## Product/Process Change Notice (PCN)

<table><tr> <th colspan="2">Before Change</th> <th>After Change</th> </tr></table>

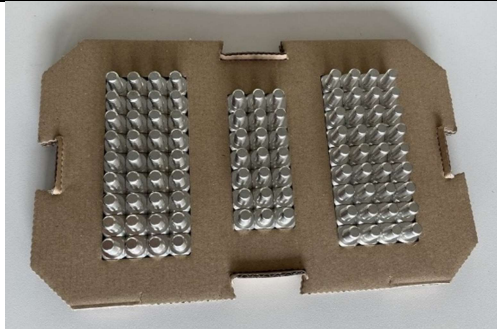
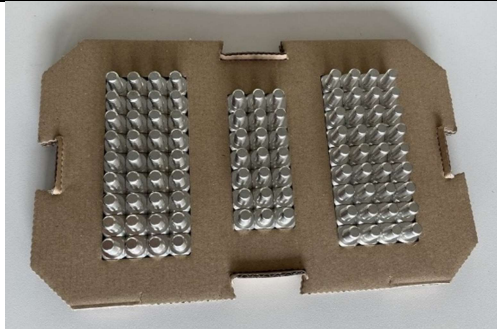
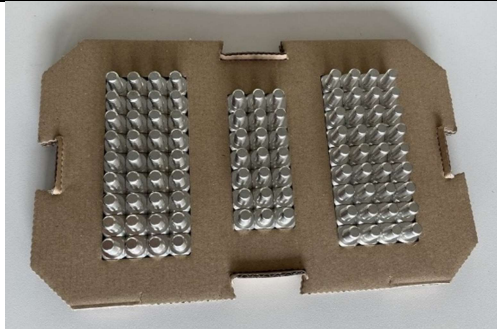
<table><tr> <th colspan="2">Before Change</th> <th>After Change</th> </tr><tr> <td colspan="2"> <b>Dimensions (LxWxH):</b><br/>           139.0 x 89.0 x 97.0 mm         </td> <td> <b>Dimensions (LxWxH):</b><br/>           274.0 x 171.0 x 15.0 mm         </td> </tr></table>

### Before Change

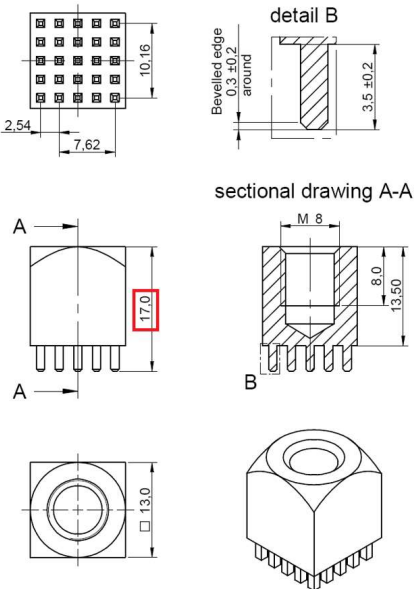
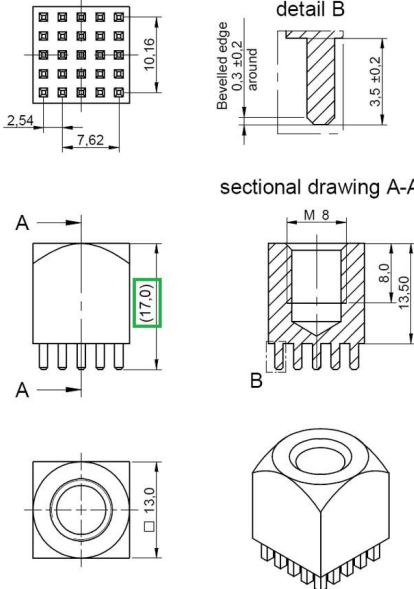
| Packaging             | Bulk              |

| Packaging             | Tray              |

| Before Change                                                                                                                                                                                                                                                     | After Change                                                                        |
|-------------------------------------------------------------------------------------------------------------------------------------------------------------------------------------------------------------------------------------------------------------------|-------------------------------------------------------------------------------------|
| <b>Dimension in the drawing without bracket:</b>                                                                                                                                                                                                                  | <b>Dimension in the drawing with bracket:</b>                                       |
| 17.0                                                                                                                                                                                                                                                              | (17.0)                                                                              |
